August 14, 2015  
Subject: **Downtown Auburn  
Transportation Center**  
State WIN: 12326.00  
**Amendment No. 6**

Make the following changes to the Bid Documents:

**C102**

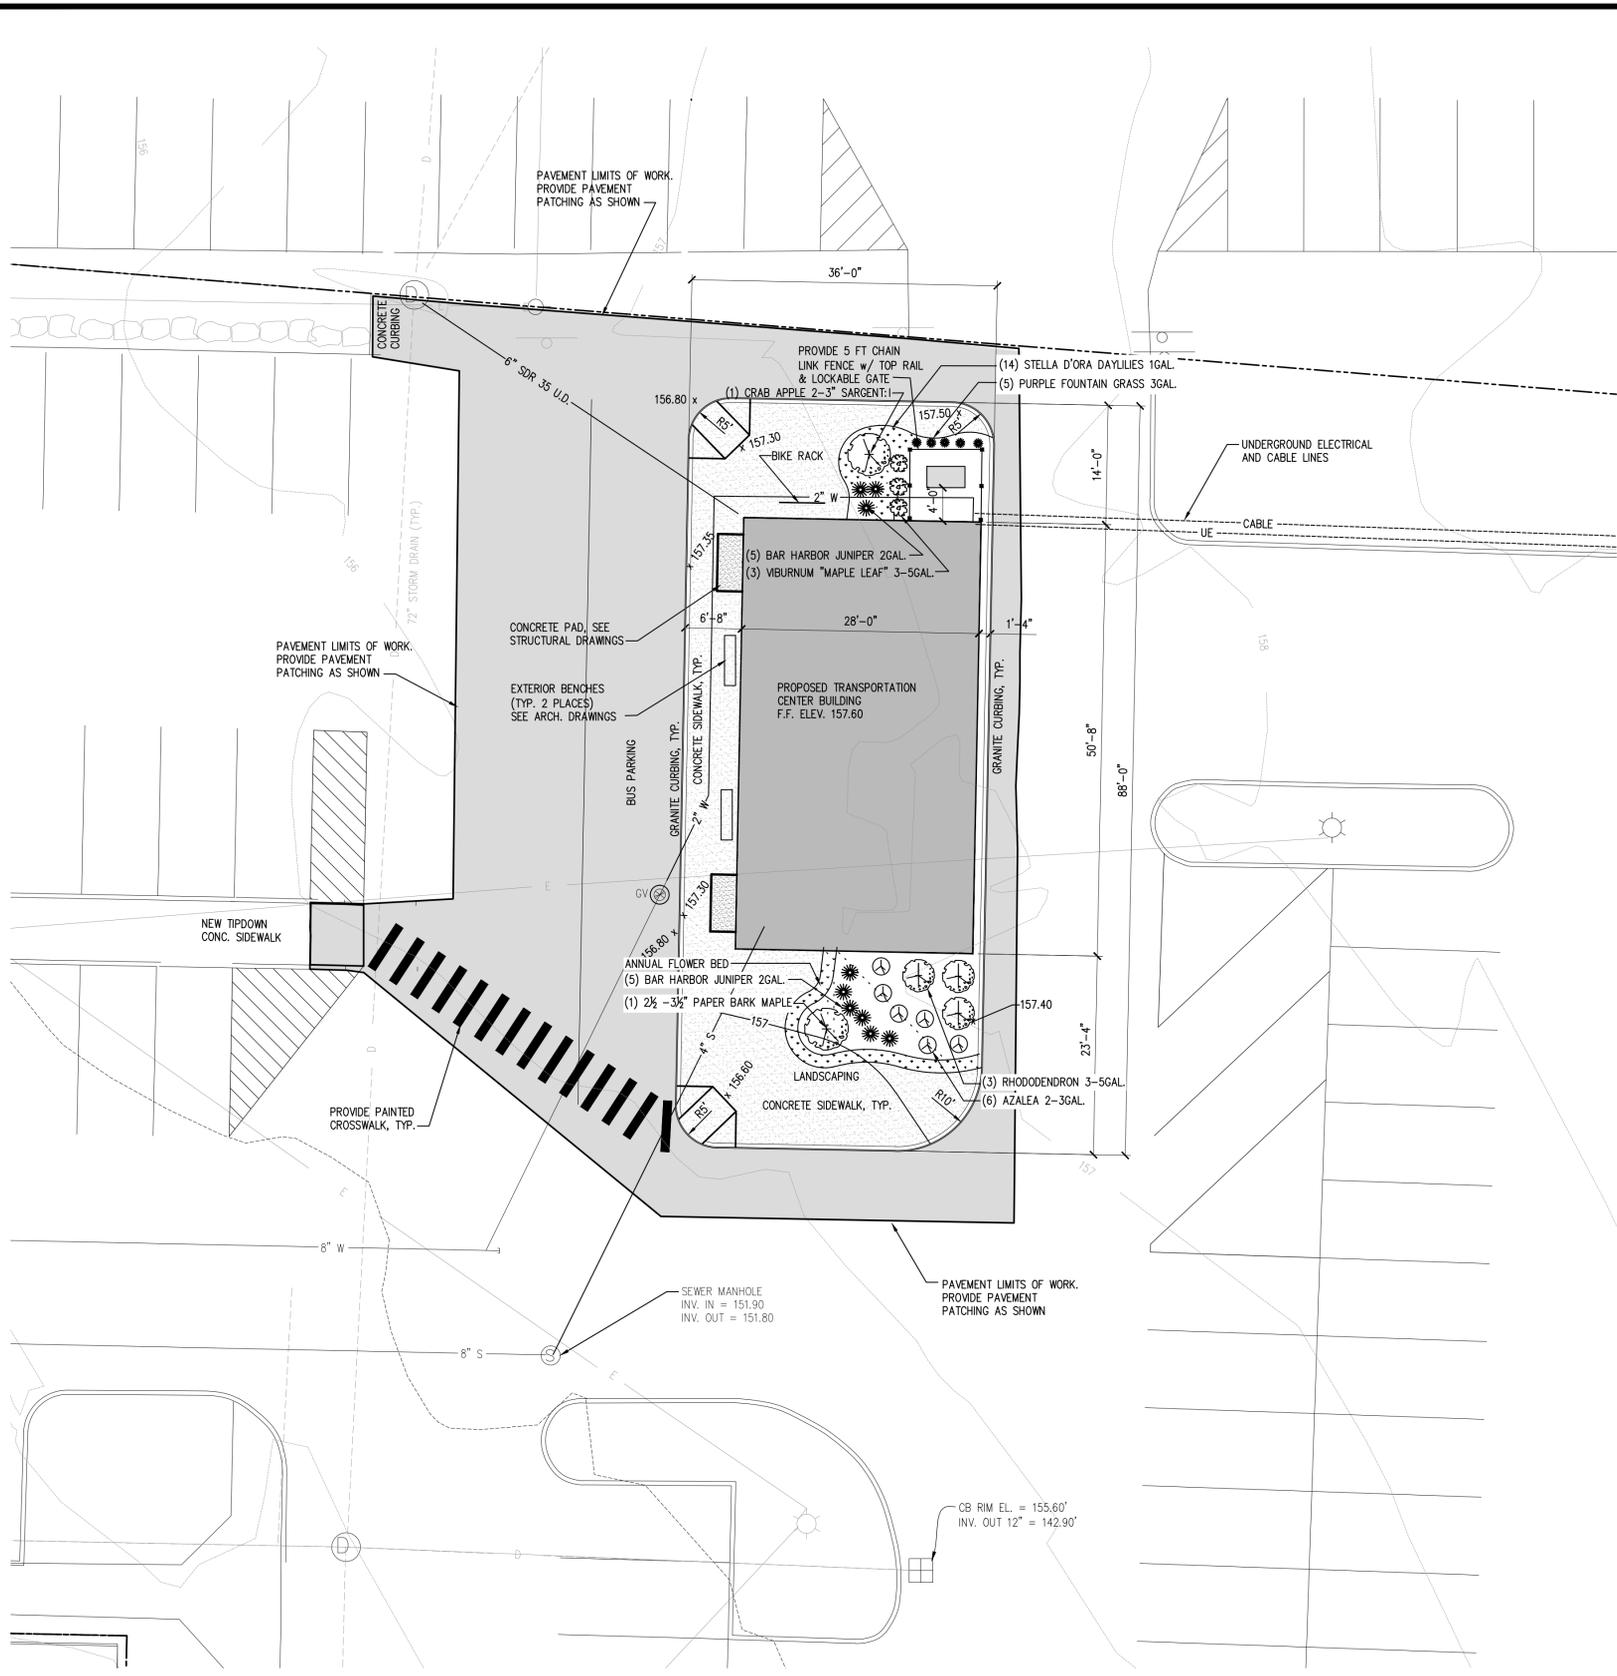
**Question:** C102 shows 5' composite fence, the bid form calls for 25 LF chain link fence. Please clarify.

**Question:** The Site Plans show a Landscape Area without any other information. The Schedule of Items 621.003 indicates a lump sum with plant group, see 6-75; however, no direction is provided. Please advise.

**Question:** Sheet C102 shows a run of 6" SDR 35 UD coming from the building and connecting to an existing catch basin. How shall this pipe be paid for? There is no item for it in the Schedule of Values.

**Question:** The site drawing C102 calls out 1 new concrete tip down concrete sidewalk. Where is this included in schedule of values?

**Response:** Reference Amendment #6 for Chain Link Fence- 5 ft high under Pay Item 607.18 and Chain Link Fence Gate under Pay Item 607.23. See C102, Amendment #6, for revised Fence information.

**Response:** Reference Amendment #6 for Special Provisions Specification Section 621.10- Landscape, revised C102 identifying landscaping and revised Schedule of Values and Schedule of Items.

**Response:** Reference shaded area on C102 for Pavement Limits of Work. Pay Item Unit is Lump Sum. Category 2 is no longer part of this contract and not applicable. Pavement can be removed by sawcutting and excavator or sawcutting and milling or reclaiming.

TYPICAL PAVING SECTION NTS

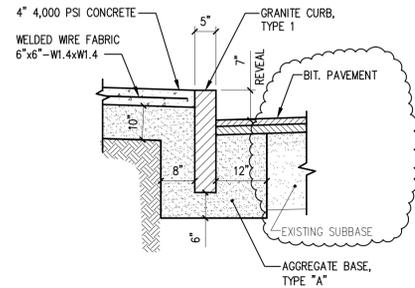
**Question:** Please clarify what is meant by "pavement patching" as called out on sheets C101/C102 of the plans.

**Question:** Please clarify where Typical Paving Section detail on Sheet C200 is to be used. Also this detail calls out both Type A gravel and Type D gravel but there is not item for the Type D gravel in the Schedule of Value. How will the type D gravel be paid for?

**Response:** Provide ancillary pavement and patching per the Special Provisions Section 321216 Asphalt Paving Section 3.2 to restore cut-out sections of pavement disturbed by

construction. Reference C102 and C200, Amendment #6, for Pavement Limits of Work and revised Typical Paving Section.

**Response:** Reference revised Typical Paving Section detail on C200, Amendment #6, which utilizes Existing Base and Subbase Course rather than Type A and Type D gravel. This detail shall be used for all pavement installed on this project. Reference revised Typical Underground Pipe Trench detail on C200, Amendment #6, which utilizes Type A gravel and Type D gravel over the pipe trench; Item 304.10 has been added to Schedule of Values and Schedule of Items in Amendment #6 to include Type D gravel.

TYPICAL UNDERGROUND PIPE TRENCH NTS

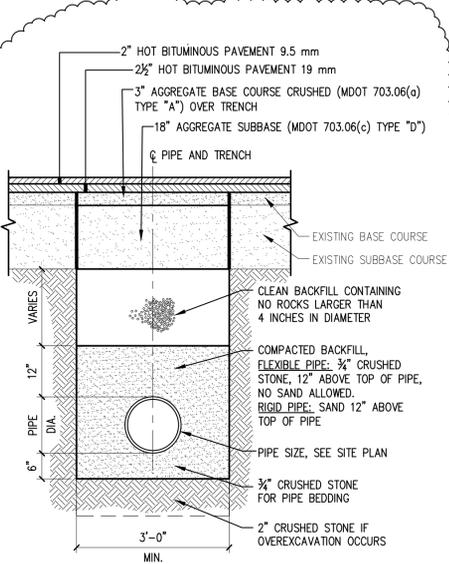
**Question:** The Underground Pipe Trench Detail shown on Sheet C201 has different pavement thicknesses shown than the Typical Pavement Detail. Please Clarify with thicknesses are correct. Also as with question #2, Type D gravel is shown in the detail but there is no pay item in the Schedule of Values.

**Question:** Also in the Underground Pipe Trench Detail, the type of compacted backfill used is determined by the classification of the pipe installed. Please clarify what is going to be considered flexible pipe vs rigid pipe. Also if sand is to be used for backfilling, is it to be used as bedding as well?

**Response:** Pavement thicknesses in the Typical Paving Section detail are correct. Reference revised Underground Pipe Trench Detail for revised pavement thicknesses and Typical Paving Section for other modifications, both on Drawing C200 in Amendment #6. Item 403.207 shall be used for 2½" bituminous concrete 19 mm and Item 403.211 shall be used for surface 2" bituminous concrete 9.5 mm. Updated quantities for each are shown in the Schedule of Values and Schedule of Items in Amendment #6.

**Response:** Rigid piping is rigid and cannot be altered or bent (ex. SDR 35 or metal), flexible pipe can be bent (drainage pipe). Sand is to be used in backfilling as well as bedding. Pay item for compacted backfill and/or sand shall be included within the various utility pay items. Reference Amendment #6 for revised Schedule of Values and Schedule of Items.

**Response:** Aggregate Base Course Type A is to be used beneath concrete walkways and above Typical Underground Pipe Trench Detail as indicated on C200 in Amendment #6. Reference revised Schedule of Values and Schedule of Items for updated quantities.
